REFERRAL REPORT

TO: Vancouver City Council

FROM: General Manager of Planning, Urban Design and Sustainability

SUBJECT: CD-1 Rezoning: 1369-1381 Kingsway

Figure 4: Recommended Amenity Space

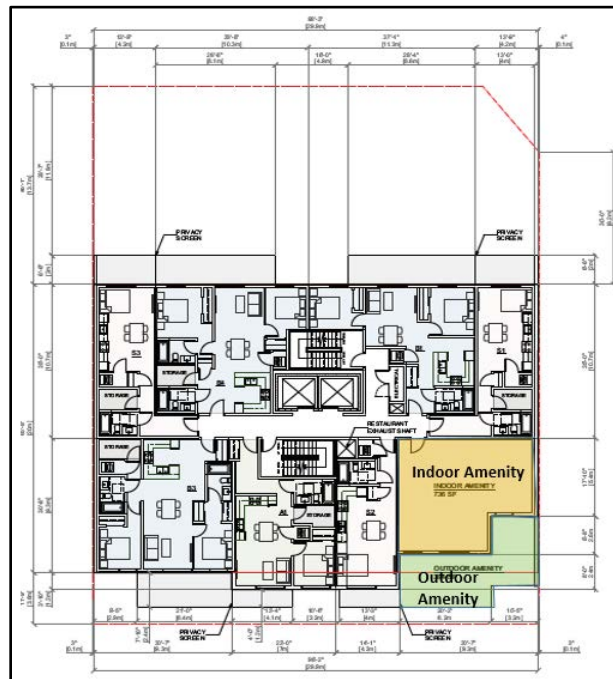
Amenity Space – This application proposes an indoor and outdoor amenity space on the second floor for residents of the building. The outdoor space is on the north-facing roof deck and both indoor and outdoor amenities are small in size. Staff recommend improving the indoor and outdoor amenity areas to accommodate on-site activity for both children and adults, and to be situated to maximize sunlight access. Figure 4 shows an example of how the amenity design may change to accommodate design conditions in Appendix B. For example, the amenity area is relocated from the northwest corner of the second level to the southeast corner of level six which allows for greater access to sunlight. The size of the amenity area is increased from 45 sq. m. to 68 sq. m. (485 sq. ft. to 736 sq. ft.) to accommodate a greater range of uses.

- (a) Increase the size of the indoor amenity to approximately 735 sq. ft. (15 sq. ft. per unit), or supplement with another indoor amenity space;
 - (b) Provide a usable rooftop, where direct sunlight is readily available, that accommodates a play and socializing areas as well as urban agriculture opportunities
 - (c) Relocate the children's play to a safer location away from the building edge.
- 1.2 Design development at the Development Permit phase, to reduce the building's visual impact and massing as follows:
- (a) Visually lighten the top two floors by use of materials, colour, and increased glazing;
 - (b) Lighting the proportions of the top floor fascia along Kingsway;
 - (c) Reduce the top floor overhang on the north to reduce overshadowing.
- 1.3 Design development to refine architectural expression and materiality at the Development Permit stage;
